CITY COUNCIL AGENDA ITEM
CITY OF SHORELINE, WASHINGTON

AGENDA TITLE:	Adoption of Resolution No. 335 Updating the Transportation Master Plan
DEPARTMENT:	Public Works
PRESENTED BY:	Kirk McKinley, Transportation Services Manager Alicia McIntire, Senior Transportation Planner
ACTION:	<input type="checkbox"/> Ordinance <input checked="" type="checkbox"/> Resolution <input type="checkbox"/> Motion <input type="checkbox"/> Discussion

RESOLUTION NO. 335

EXHIBIT A – RECOMMENDED CHANGES TO THE TRANSPORTATION MASTER PLAN

Figure A

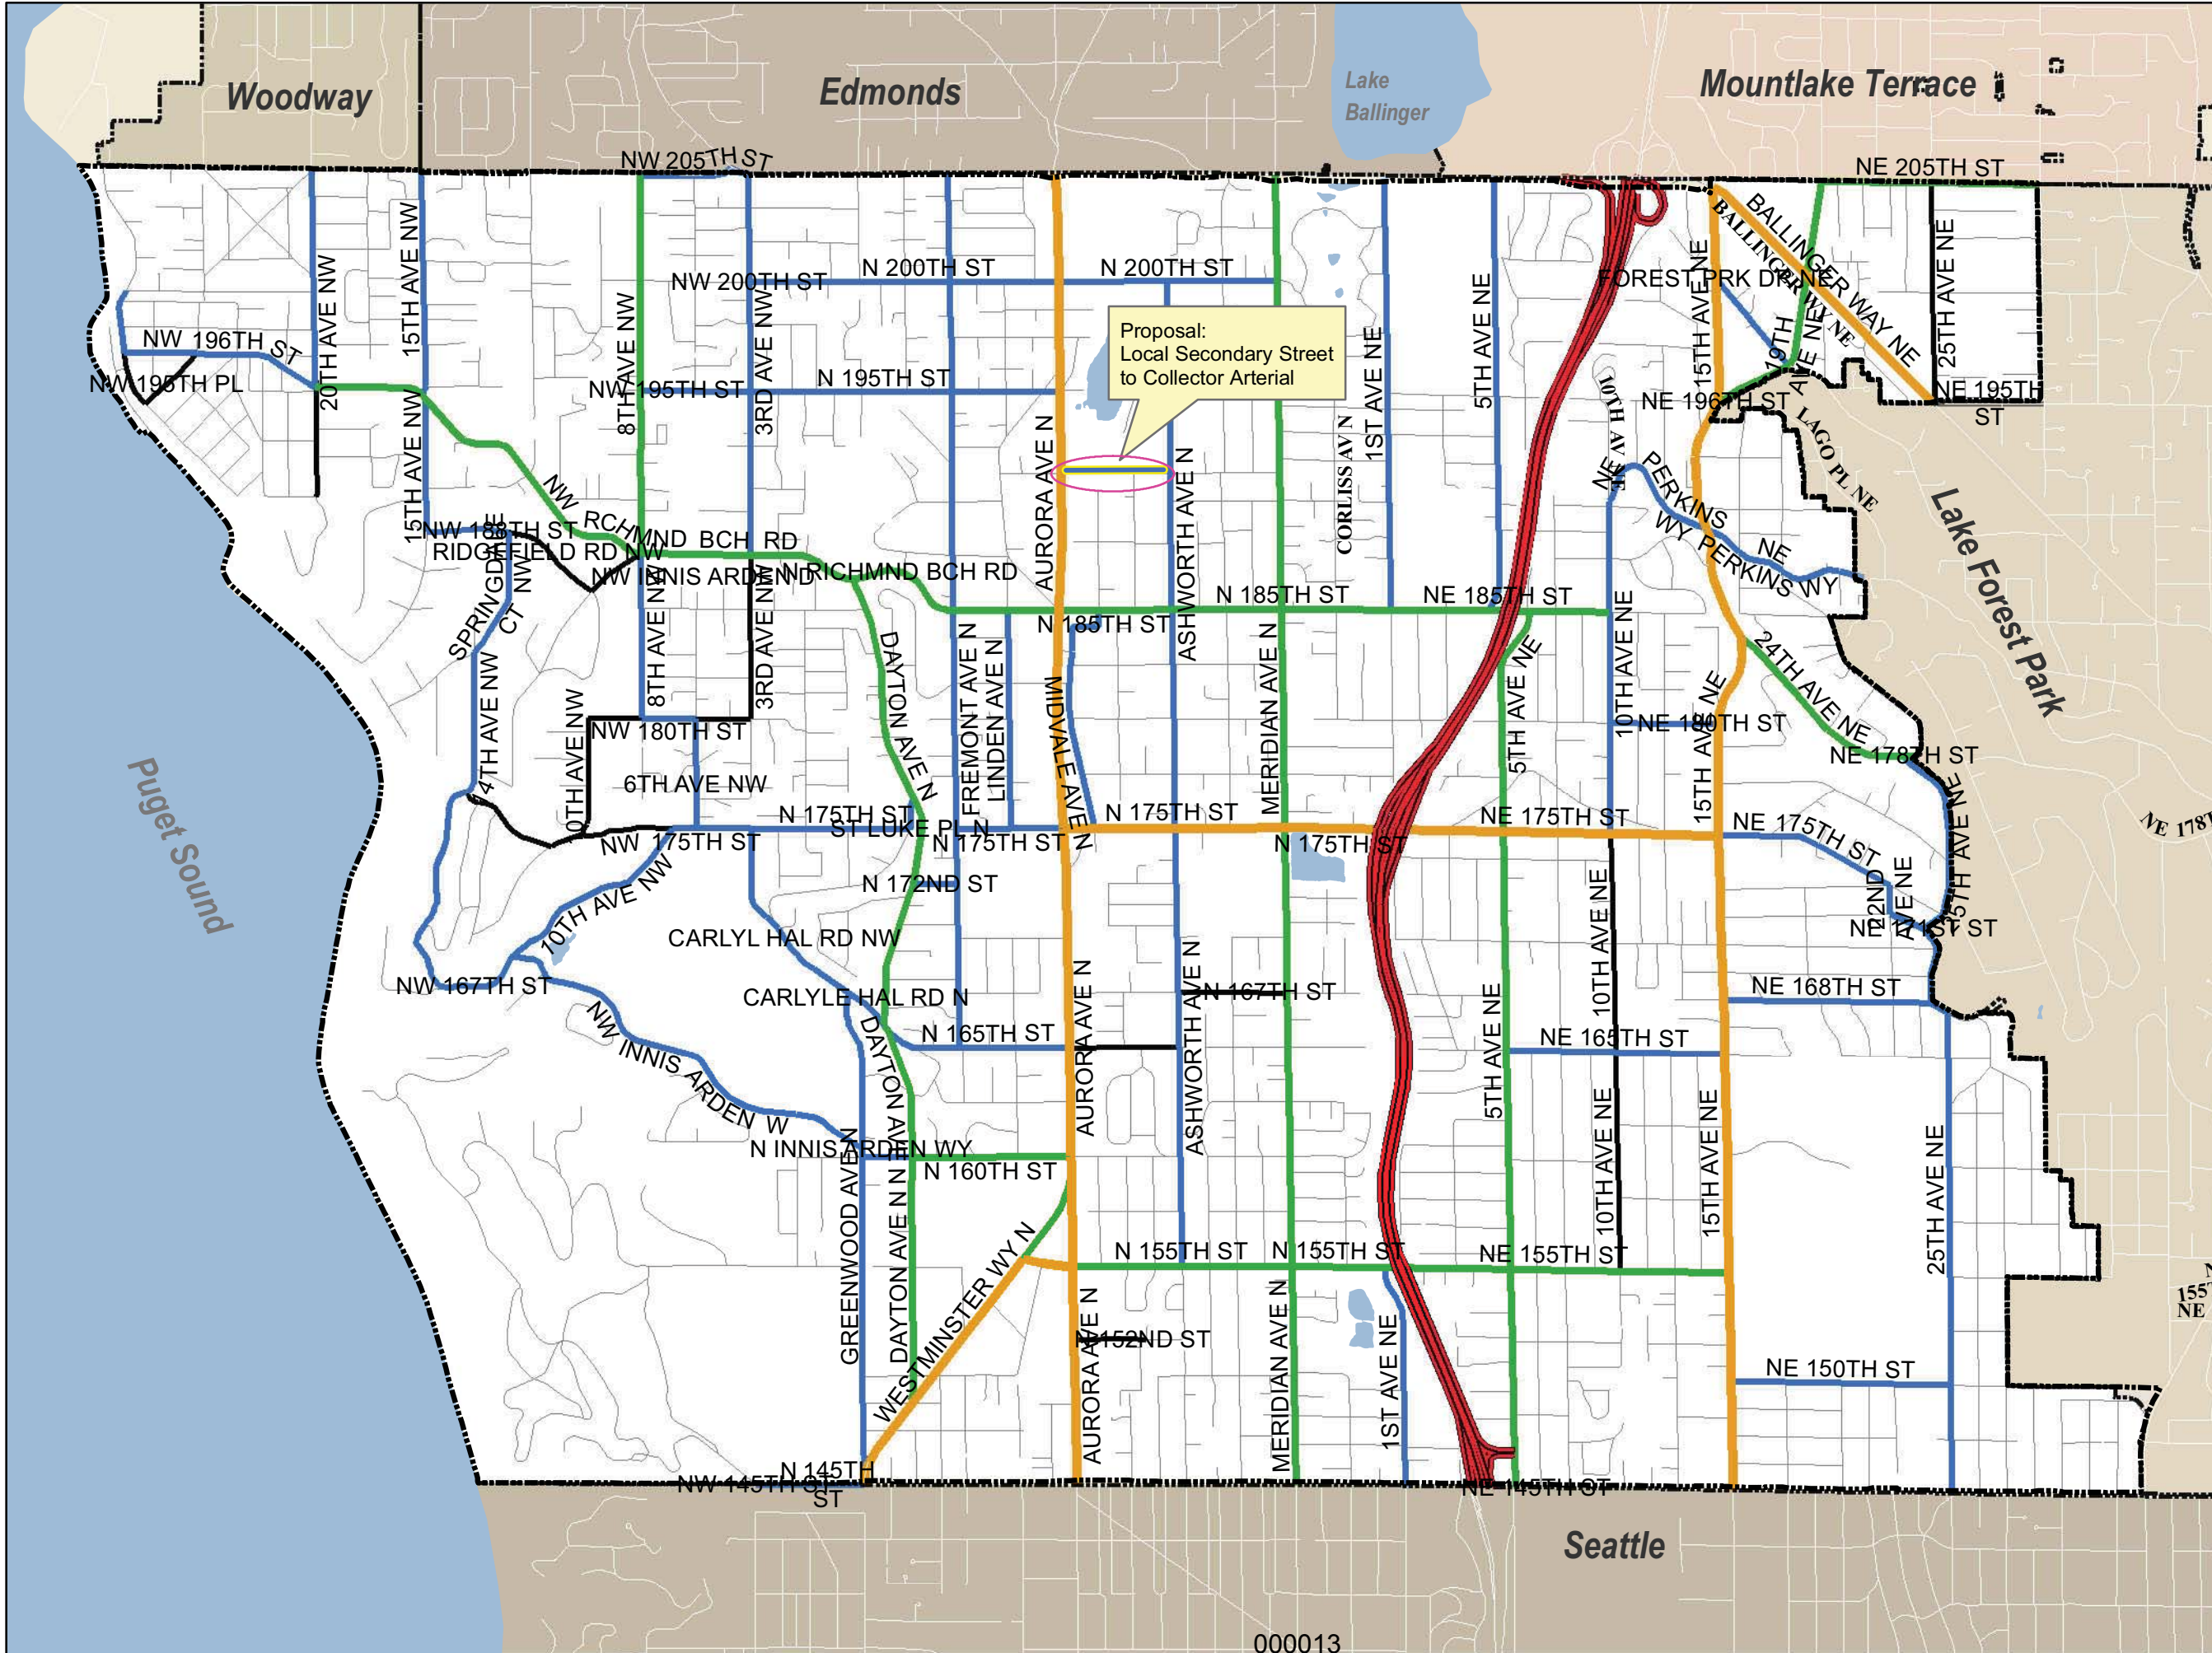
PAGE	SUBJECT	AMENDMENT	NOTES/EXPLANATION
1	Page 29 (Figure A)	Street Classification	Change the street classification of N 192nd Street from Aurora Avenue N to Ashworth Avenue N from Local Secondary Street to Collector Arterial (See attached)	Per previous discussions with Council.
2	Page 175 (Figure V)	Light Rail Alignment	Remove Aurora Avenue N and the two potential light rail stations as alternatives identified as Light Rail Station Scenario Options. Correct the legend accordingly (See attached)	Sound Transit is now considering Interstate 5 as the only alignment option for the Lynnwood Link Light Rail extension as part of the Draft Environmental Impact Statement. The station locations shown on the figure are consistent with Council's stated preference for station area locations.
3	Page 178	Master Street Plan	The planned cross-sections establish the location of future curbs so that streets can be constructed in the proper location. <u>It should be noted that the identified cross-sections do not necessarily include the full right-of-way width that may be needed at intersections to accommodate additional facilities, such as turn lanes. These right-of-way needs, including those for identified projects needed to accommodate future growth, will be determined at the time of development permit application and/or capital project design.</u>	Added to provide clarification.
